HISTORIC AND DESIGN REVIEW COMMISSION

December 6, 2017

HDRC CASE NO: 2017-566
ADDRESS: 402 CENTER ST
406 CENTER ST
139 N SWISS
126 N CHERRY
122 N CHERRY
120 N CHERRY
134 N SWISS
130 N SWISS
126 N SWISS
LEGAL DESCRIPTION: NCB 590 BLK 3 LOT N 40 FT OF 1
NCB 590 BLK 3 LOT N 40 FT OF 2
NCB 590 BLK 3 LOT 3
NCB 590 BLK 3 LOT S 47.52 FT OF N 87.52 FT OF 1 & 2 ARB A16
NCB 590 BLK 3 LOT N 32.5 FT OF S 65 FT OF 1 & 2
NCB 590 BLK 3 S 32.5 FT OF 1 & 2 ARB A17
NCB 590 BLK 3 LOT N 50 FT OF 18 & 19
NCB 590 BLK 3 LOT S 45 FT OF N 95 FT OF 18 & 19 ARB A-29
NCB 590 BLK 3 LOT S 43.45 FT OF 18 & 19 ARB A-30
ZONING: IDZ, HE, C-3
CITY COUNCIL DIST.: 2
DISTRICT: Dignowity Hill Historic District
APPLICANT: Ricardo Turrubiates
OWNER: K/T TX Holding, LLC
TYPE OF WORK: Conceptual approval of a site plan for a twenty-four unit townhome development
APPLICATION RECEIVED: October 24, 2017
60-DAY REVIEW: December 23, 2017
REQUEST:

The applicant is requesting conceptual approval of a site plan for a twenty-four unit townhome development to be partially bound by N Cherry, Center and N Swiss. This request is for conceptual approval of the placement of proposed units only. Massing, materials and architectural deta

Preliminary Site Plan

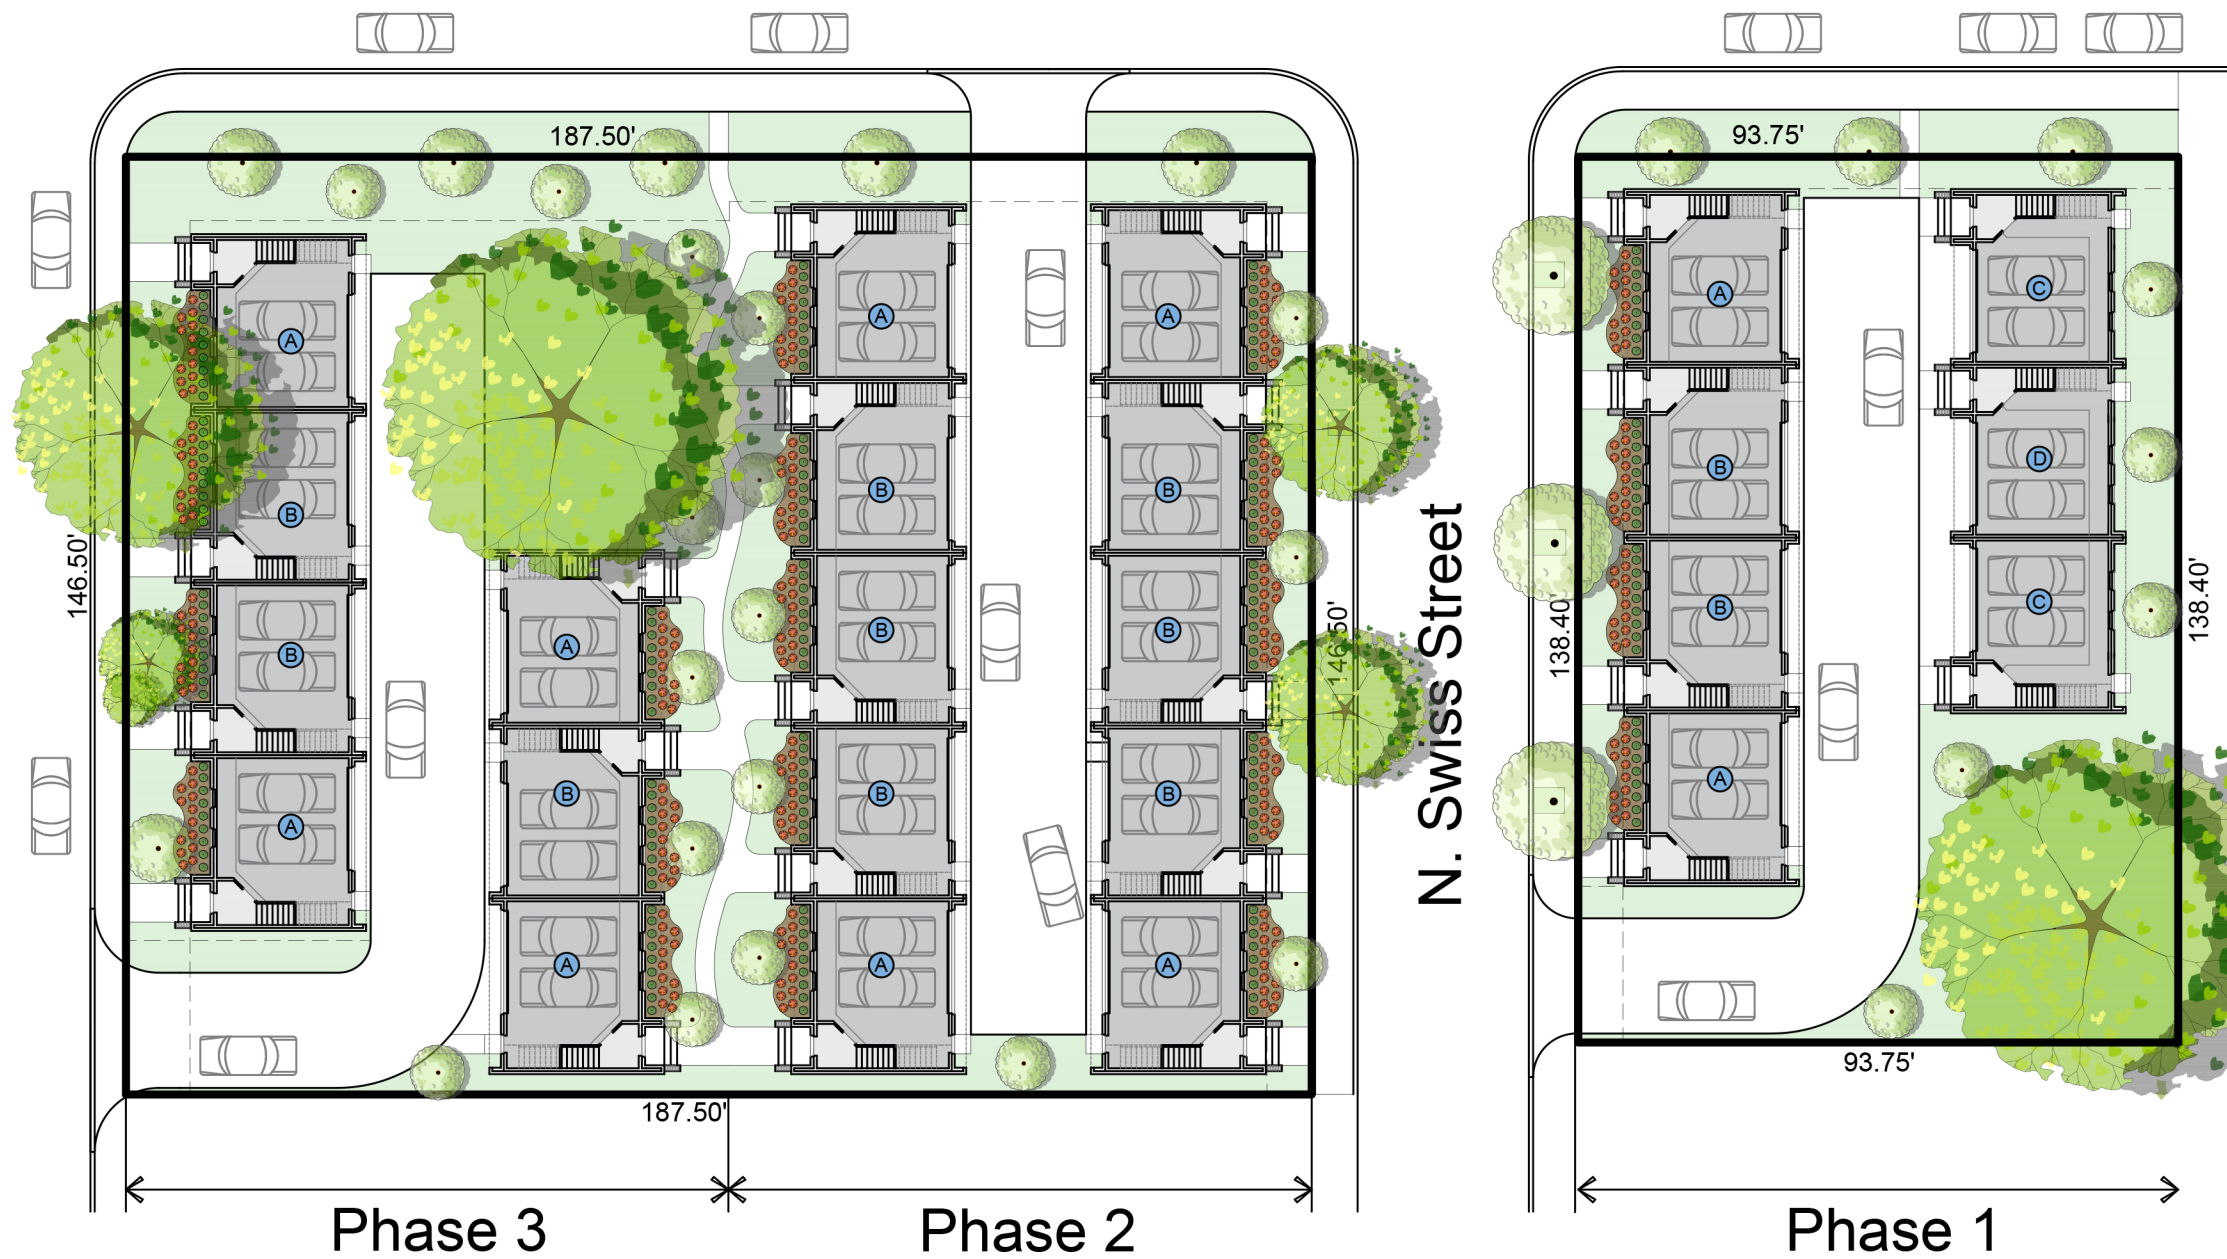
- d. **SITE PLAN** – The applicant has provided a site plan that notes that construction of twenty-four residential structures in row house form. The ground level of each structure features an automobile garage. The applicant has proposed for thirteen of the proposed units to front N Cherry Street or N Swiss.

- e. **SETBACKS** – Per the Guidelines for New Construction 1.A.i., the front facades of new construction should be aligned with the front facades of adjacent buildings where a consistent setback has been established along the street frontage. Where a variety of setbacks exist, the median setback of buildings should be used. The surrounding structures, many of which are not historic, feature varying setbacks. Staff finds that the applicant should provide a diagram noting the relationship of proposed setbacks with those found historically in the adjacent blocks. On N Swiss, the proposed new construction should feature a greater setback than the adjacent single family historic structure.

- f. **ORIENTATION** – The applicant has proposed an orientation that results in thirteen of the proposed twenty four units to front either N Cherry or N Swiss Streets. Eleven of the proposed units will feature an inward orientation. Generally, staff finds the units that have been proposed to front N Swiss and N Cherry to be appropriate and consistent with the Guidelines. There are currently four units that are adjacent to Center Street but do not feature an orientation toward Center. Staff finds that the applicant should incorporate porch and other architectural elements to reorient these units toward Center Street.

- g. **SITE DESIGN** – The applicant has noted the installation of natural lawn areas that are to include planting beds at the front of each structure. Additionally, the applicant has provided information regarding site design including the location of driveways, walkways and sidewalks and trees. Generally, the proposed locations of grass and plants are appropriate.

- h. **WALKWAYS** – The applicant has proposed sidewalks to extend between row structures as well as sidewalks to extend from front porches to the connecting sidewalks. Staff finds this appropriate; however, sidewalks that extend to Center Street should feature a width that is consistent with that found historically in the district.

- i. **DRIVEWAYS** – The applicant has noted driveway entrances that are to be located on N Cherry, Center and N Swiss Streets. Each of the propose driveway widths as well as curb cut and apron widths are wider than what is found historically in the district. Staff finds the location of the proposed driveways to be generally appropriate; however, staff finds that the applicant should provide additional information regarding exact widths, materials and curb cut and apron widths.

The proposed building footprints and scale are appropriate in the given context. However, staff cannot make a positive recommendation at this time due to a lack of information. Staff recommends that the applicant continue to develop the proposal with the following considerations:

- i. That the applicant provide a diagram noting the relationship of proposed setbacks with those found historically in the adjacent blocks.
- ii. That the proposed new construction which fronts N Swiss feature a similar setback as that of the neighboring historic structure.
- iii. That units which feature a side elevation toward Center Street be reoriented to feature a primary orientation toward Center or be designed to provide architectural interest along Center.
- iv. That the fenestration pattern be developed to feature traditional solids to voids ratios and avoid the placement of blank walls with exposure to the street.
- v. That the applicant explore alternative configurations that reduce the number of curb cuts / private driveways.
- vi. That the applicant provide information regarding the width, profile and materials of each driveway, apron and

curb cut.

- vii. That all sidewalks which intersect the sidewalk at Center feature a width and profile that is consistent with those found historically in the district.
